Up-armored  
HMMWVs...

# CONDENSER FAN ASSEMBLY CHANGES

Improved rear condenser allows for more clearance and has stronger panel

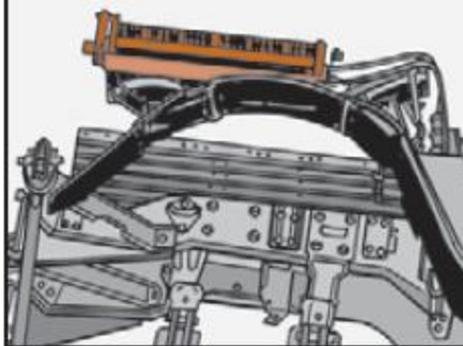
AN UPGRADED REAR AIR CONDITIONER CONDENSER IMPROVES YOUR M1151, M1152, AND M1165 BASIC AND -A1 UP-ARMORED HMMWVs.

THIS NEWER CONDENSER ALLOWS FOR MORE CLEARANCE, HAS A BEEFED-UP CLOSEOUT PANEL, AND SHOULD CURB POTENTIAL DAMAGE.

The original rear condensers, NSN 4130-01-537-4847 and NSN 4130-01-536-5561, are no longer available. But you can get the replacement condensers, closeout panel and related hardware in upgrade kits that TACOM LCMC assembled.

Order the left-hand rear condenser kit using NSN 2540-01-558-3448, and the right-hand rear condenser kit using NSN 2540-01-558-3450.

Two fans that pull the air through are mounted underneath the condenser. Get the front condenser fan with NSN 4140-01-548-2496 and the rear condenser fan using NSN 4140-01-548-1171.
